Technical Service Bulletin: TSB230192

New Front Gear Cover Gasket

- QSK19 (All versions)

Figure 1, Front Gear Cover Gasket Rubber Retention Locations.

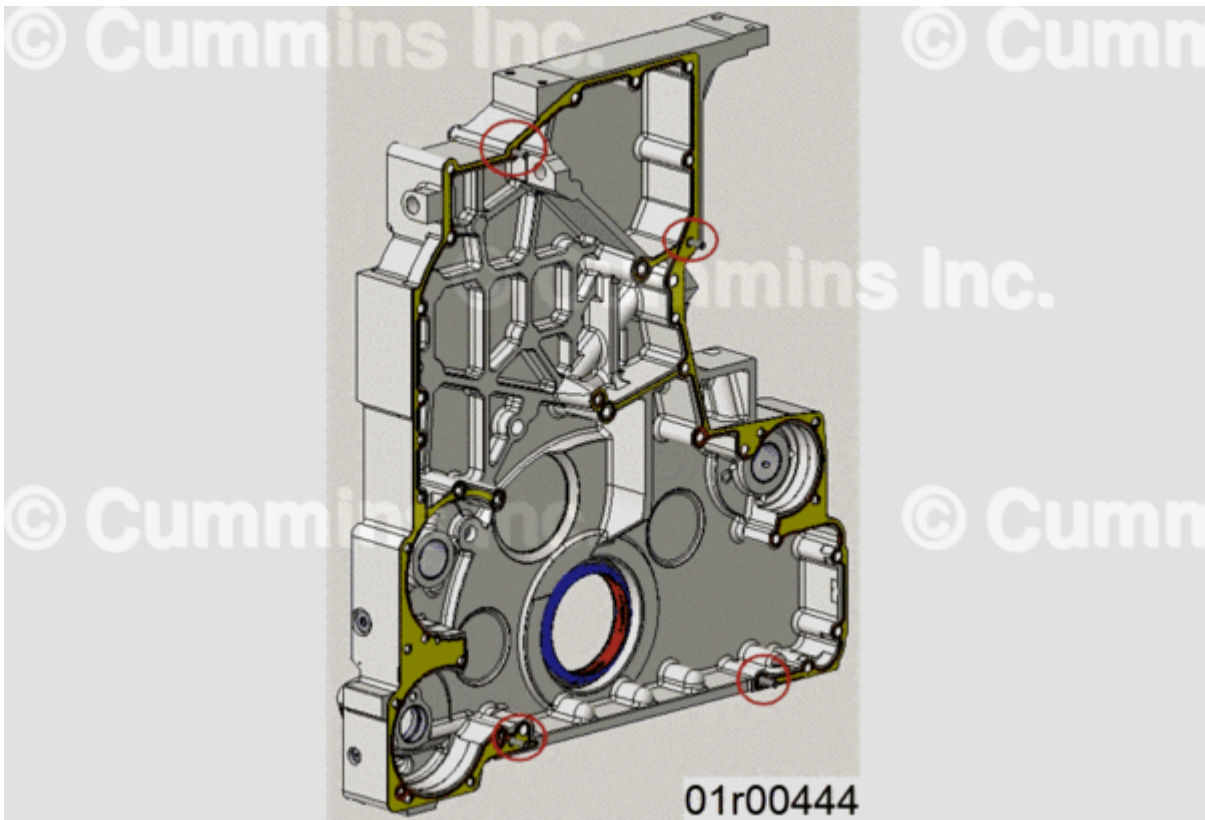
This document announces the new edge molded front gear cover gasket.

The new front gear cover gasket addresses engine oil leakage malfunctions.

- Front gear cover removal, cleaning, and inspection, see corresponding Service Manual. Reference Procedure 001-031 in Section 1.
- Do **not** use RTV or gasket adhesive during the installation of the front gear cover.
- The revised front gear cover gasket has four capscrew locations with a rubber retention feature to aid with assembly. See Figure 1.
